On the following pages is an excerpt from the “Information needed for Registration of SABIA X1-XP Materials Analyzer” taken from your letter of June 19, 2013. In each section, I have repeated the question or comment, and have attempted to provide the required information beneath each section.

SABIA Inc 's Application dated March 29. 2013
Information Needed for
Registration of SABIA X1.XP Materials Analyzer

Detail photo of source housing of SABIA X-1 analyzer, showing source holders installed into one source location.

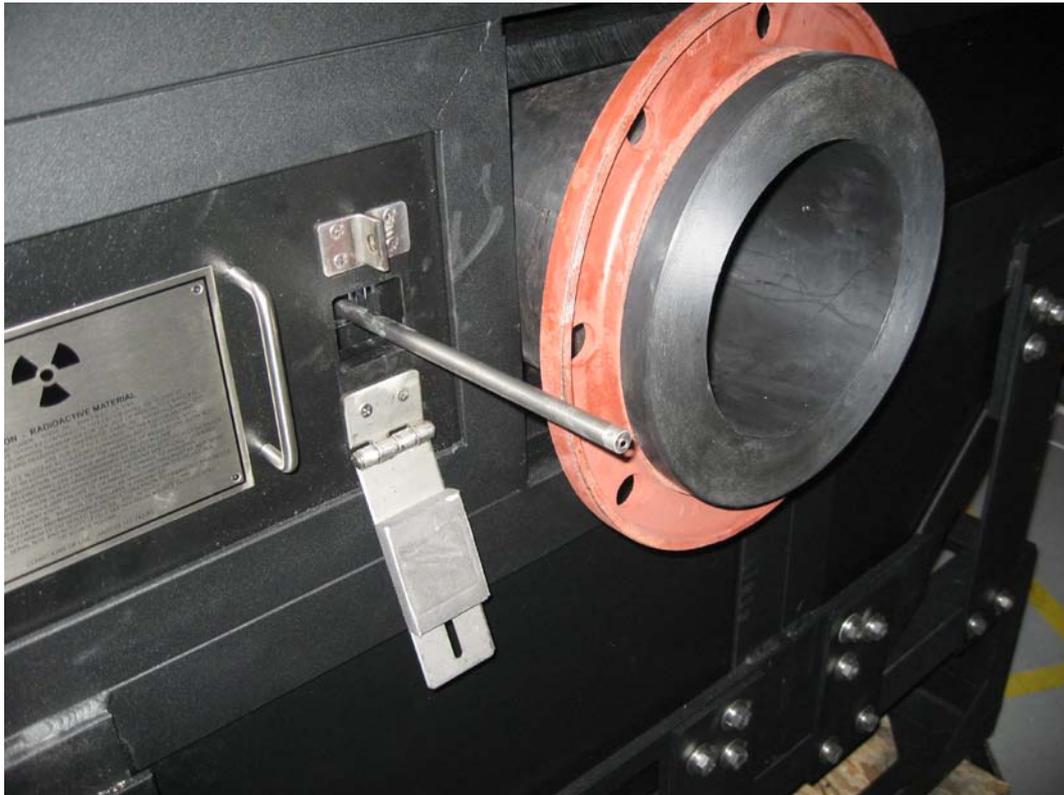
- 1.2.1 The drawing provided on Page 16 does not indicate how the source will be secured in the source holder Please provide a detailed engineering drawing for the source holder and specify how the source will be mounted.

- 1.2.2 Provide drawings that illustrate how four individual sources are to be mounted in the source holder (Page 4, Paragraph 1).

Additional details are provided in the attached color photos, showing details of the source holder, source housing, locking mechanism, and security lock.

Please see attached color photos, illustrating the mounting of four individual source holders in the source housing.
